NESC Review of the 8-Foot High Temperature Tunnel (HTT) Oxygen Storage Pressure Vessel Inspection Requirements

NASA Engineering and Safety Center Technical Consultation Report	Document #: RP-05-113	Version: 1.0
Title: NESC Review of the 8-Foot High Temperature Tunnel (HTT) Oxygen Storage Pressure Vessel Inspection Requirements			Page #: 1 of 29

March 16, 2006

Appendix B. LOX Run Tank Sketch

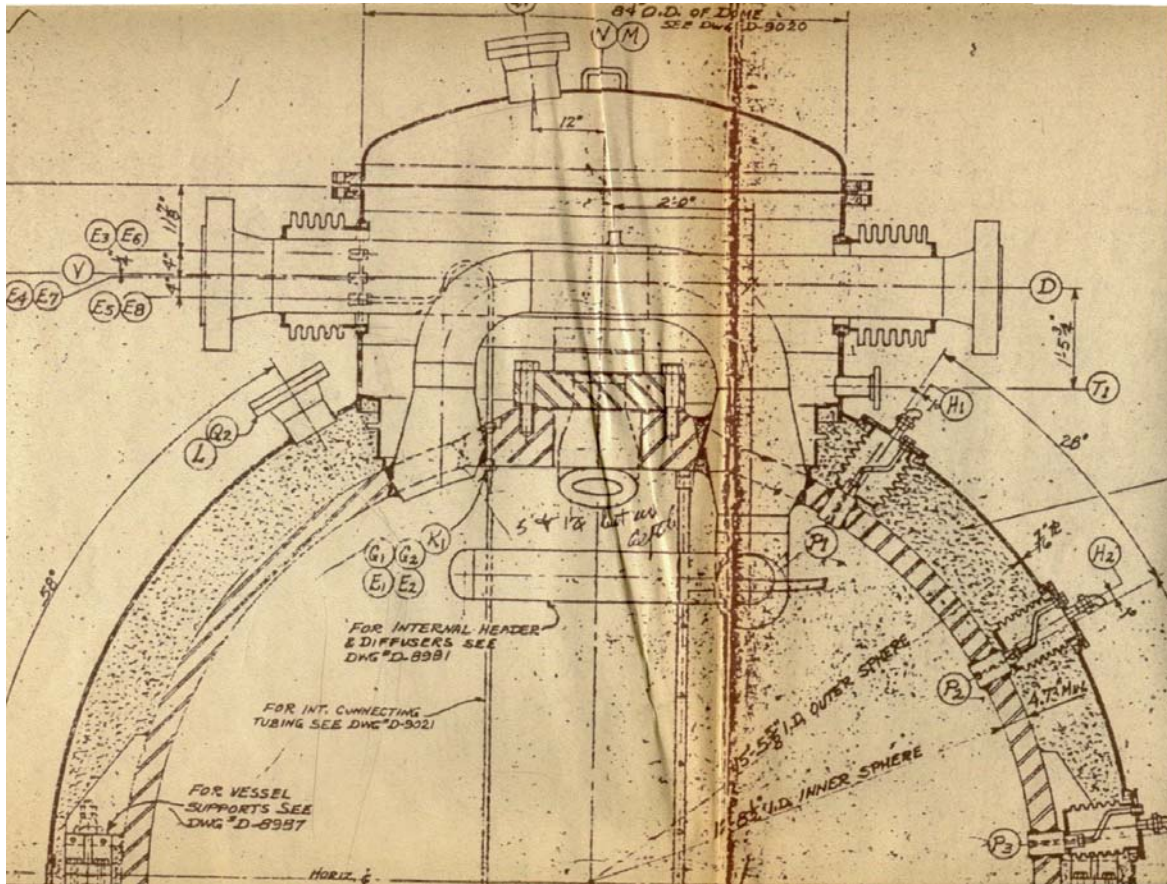
- The tank was determined to be LBB by analysis.
- Monitoring of the vacuum level between the inner pressure shell and the external shell would identify the presence of through-cracks in the pressure shell and allow the facility to stop operations before catastrophic failure would occur.

- F-1.** The damage tolerance analyses are insufficient to demonstrate LBB for the LOX Run Tank for the following reasons:
- Critical crack size is predicted to be less than the tank wall thickness.
 - Fracture mechanics analyses did not account for weld material properties or residual stresses.
 - The structural finite element models do not capture changes in thickness, geometry, loading, and material properties.

The tank, as constructed, contains welded-in forgings for the upper access port and nozzles at both the top and bottom of the tank. The properties of the weld material and the forgings differ from the properties of the material used for the tank walls, even though both the tank wall and forgings are 347 Stainless Steel. The crack growth analysis assumed uniform material properties for all sections of the tank and did not include analyses of the welds. In addition, material properties for 304 Stainless Steel were used in the analyses as being representative of 347 Stainless Steel because material properties for 347 Stainless Steel were not readily available.

Although a critical crack size less than the tank wall thickness was predicted, it was assumed that the crack would also grow perpendicular to the thickness until reaching an adjacent nozzle opening, which would act as a crack stop. The crack would then be

This assumption did not account for the weldments or the changes in material properties along the assumed path of the crack and, therefore, is invalid. Also, the NASA standard for LBB is crack length 10 times the wall thickness, whereas the analysis was based on crack length 2 times the wall thickness. Refer to Observation O-3.

R-1. Remove the LOX Run Tank from run-time pressure service until the LBB rationale is verified and the risk of continued operation is accepted, or until an inspection is performed and any detected flaws are properly dispositioned (F-1, F-2, F-3, F-4 and F-6).

Appendix C. LOX Run Tank Analyses

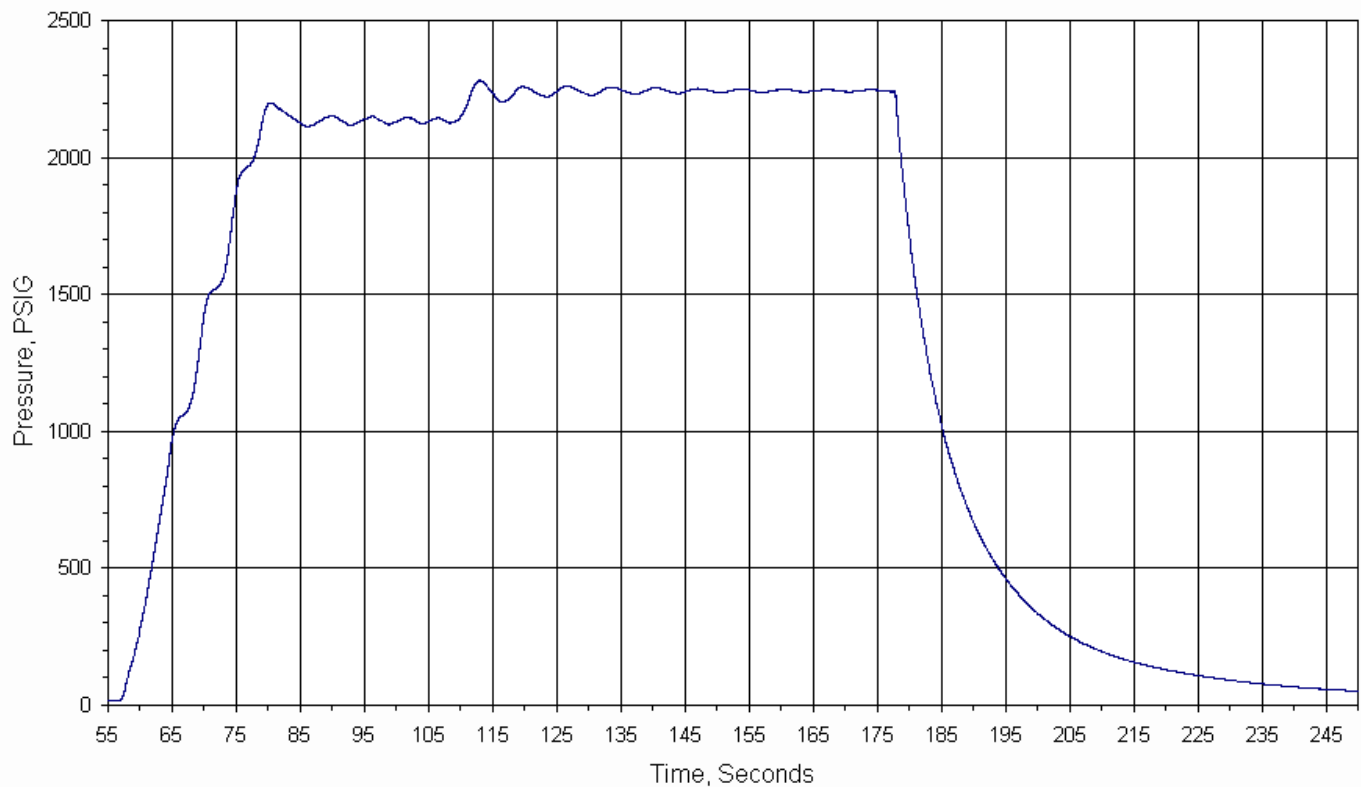
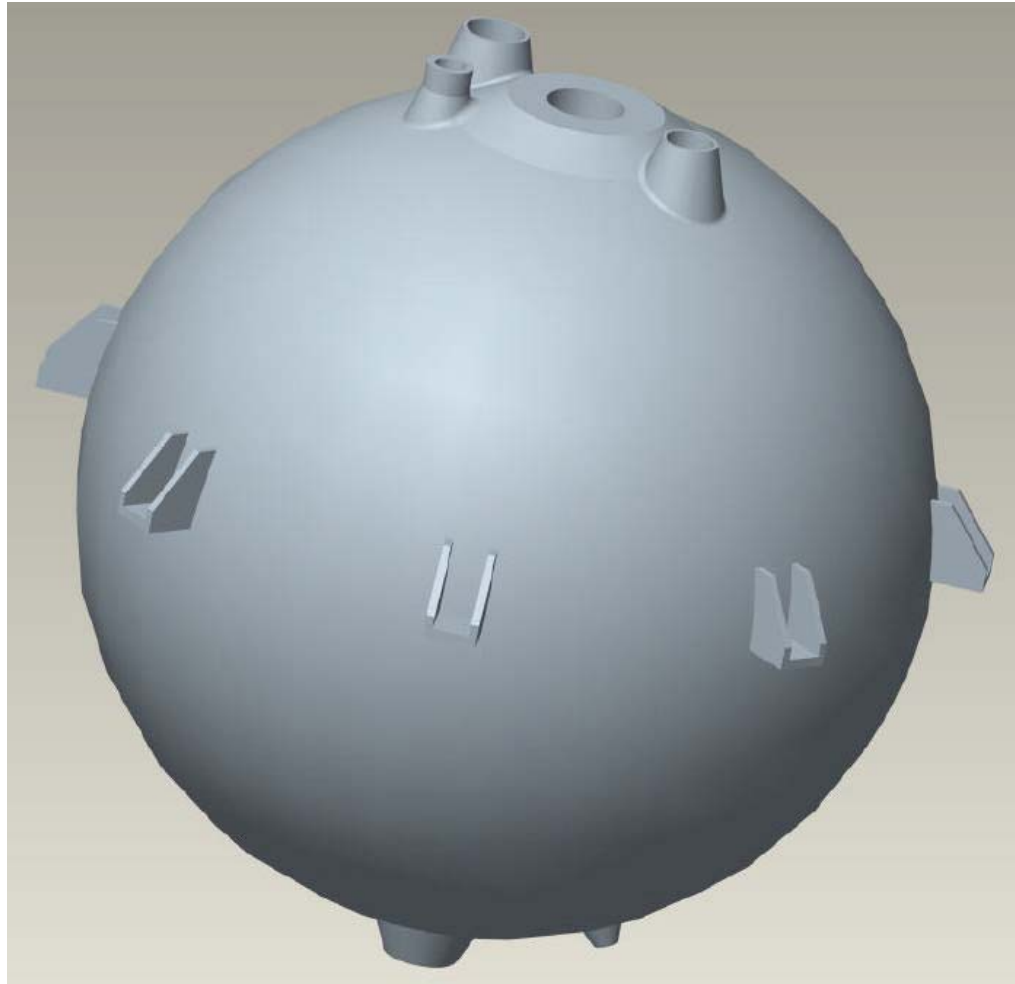
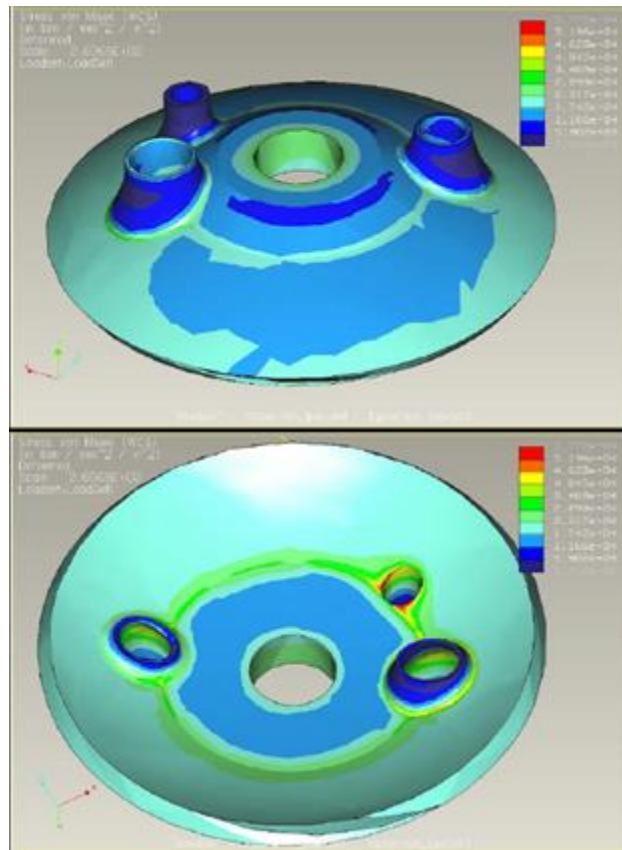
The NESC Review Team reviewed the stress, fatigue, and fracture analyses of the LOX Run Tank. The individuals that performed these analyses were interviewed by the NESC Review Team to gain full understanding and to resolve any questions. The results of the data analyses are documented in Section 8.1, Findings.

Refer to Appendix C for key analyses figures reviewed by the team.

O-4. Atmospheric pressure load modeling in the revised analysis needs to be updated; the overall effect is expected to be very minor (order of 14/2250 psi).

- The atmospheric pressure acts on the external vacuum jacket shell and transfers to the LOX Run Tank pressure shell as point loads through standoffs, not as a uniform load on the pressure shell.
